Cooperative Hydrology Study (COHYST) Independent Peer Review Findings Final Report

October 15, 2005

The purpose of the Independent Peer Review was to evaluate the credibility of the model reports, the underlying model datasets, and supporting data and information by providing answers to the following questions:

Figure 37

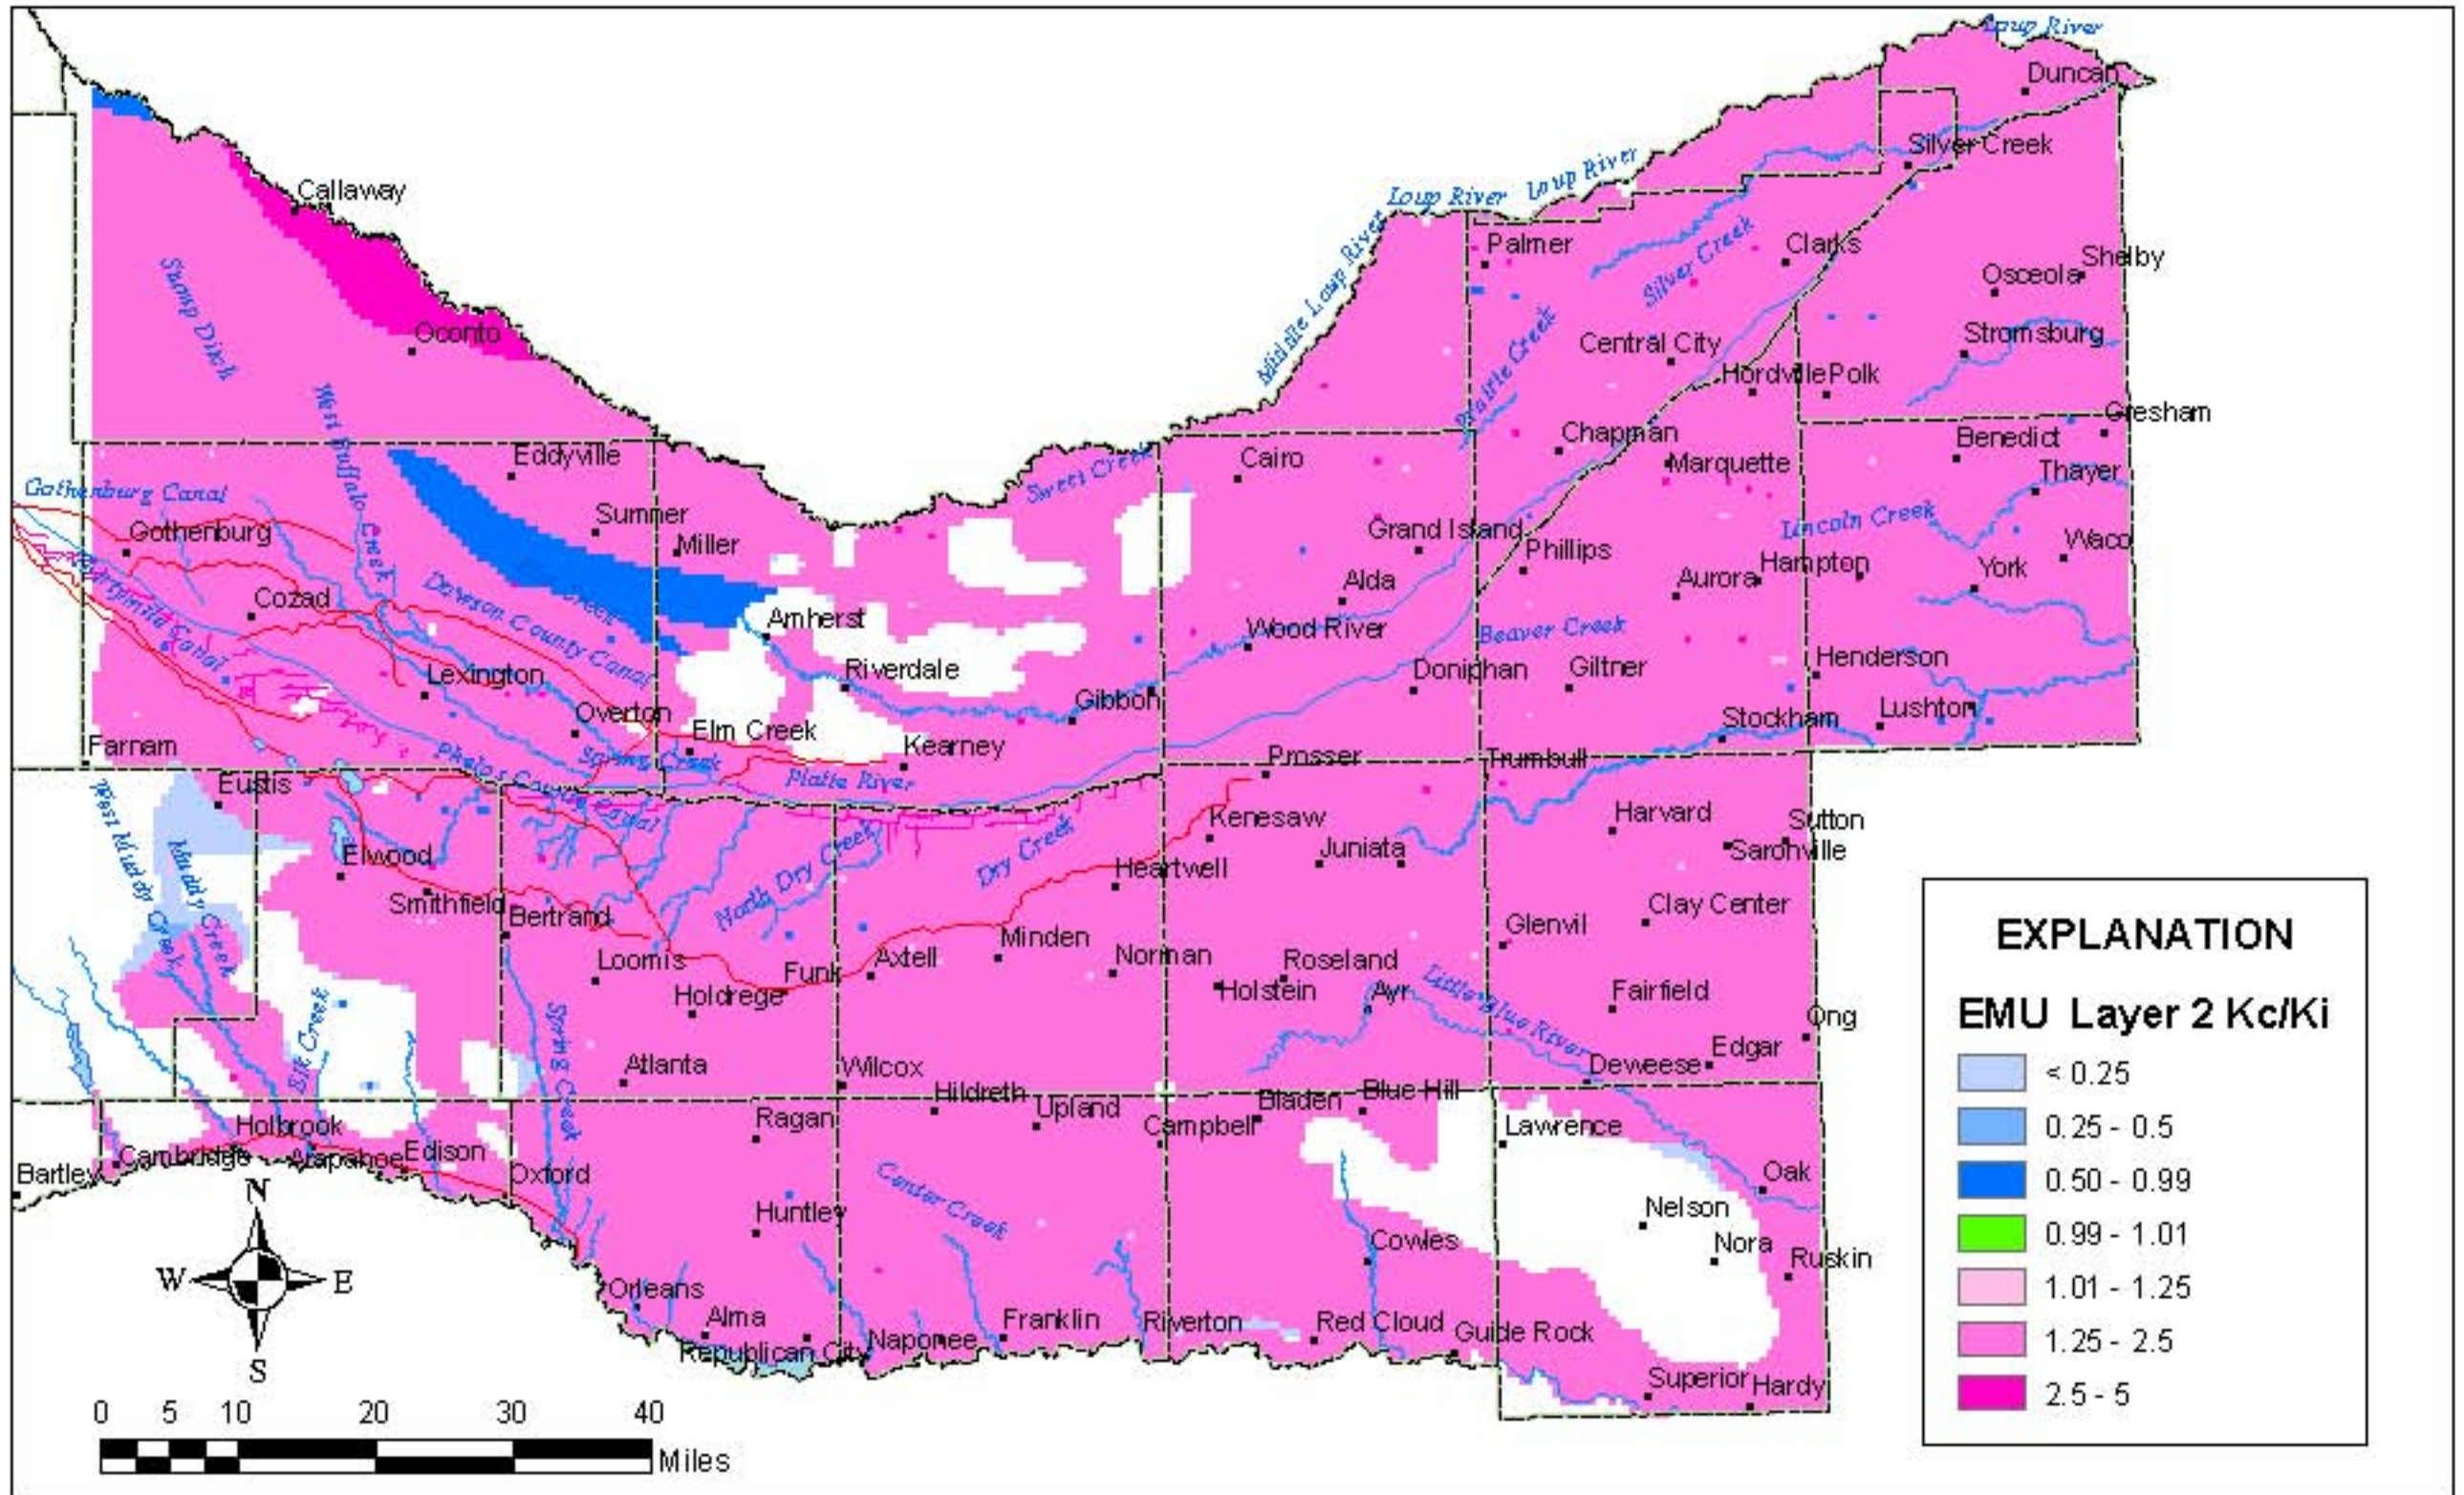
Comment 10: Section 6.5.3 (p. 52) discusses evaluation of the hydrogeology coverages. Figure 38 shows a comparison of initial hydraulic conductivity (K) compared with calibrated K and suggests that the calibrated values (model layer 2) represent 0.25 to 5.0 times the initial values. However, during the calibration, the K values for model layer 2 were uniformly multiplied by 1.6, rather than by a variable value. Similarly, a uniform multiplier (not 1.6) was applied to the K for EMU model layer 5. Additional clarification would be helpful to illustrate whether this is a misunderstanding of some sort, or if there are parts of the model documentation or the geology report that need updates or additional work.

Response: Figure 38 was prepared as follows:
